Car Stereo Service Bulletin

Model: MDX-100 No. 342

Subject: Skipping And/Or Same Portion Of Music Is Date: November 18, 1994

Continuously Repeated.

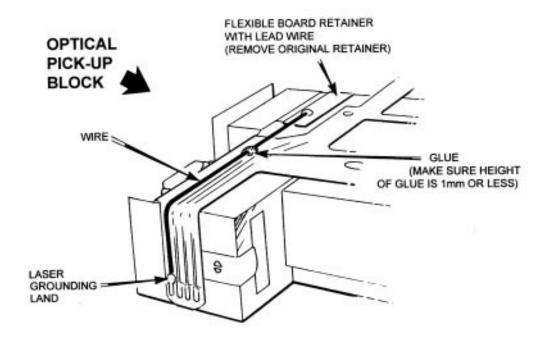
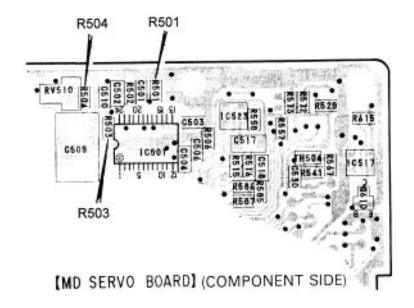
(57) The unit skips, or the same portion of the music may be continuously repeated.

- 1- Remove and discard the retainer which secures the flex cable to the optical pickup block.
- 2- Clean the area from which the retainer was removed with alcohol.
- 3- Install the new retainer which includes a lead wire.
- 4- Secure the lead wire with a small amount of glue as shown. Be sure to keep the height of the glue droplet to 1 mm or less.
- 5- Dress the lead wire snugly along the top of the optical pickup block and down the side as shown.
- 6- Solder the lead wire to the laser ground trace on the flex cable as shown.

- 7- Change the value of R501 on the MD board from 100K to 47K.
- 8- Change the value of R503 and R504 on the MD board from 200K to 180K.

Solution: If the customer complains of these symptoms, implement the changes shown below.
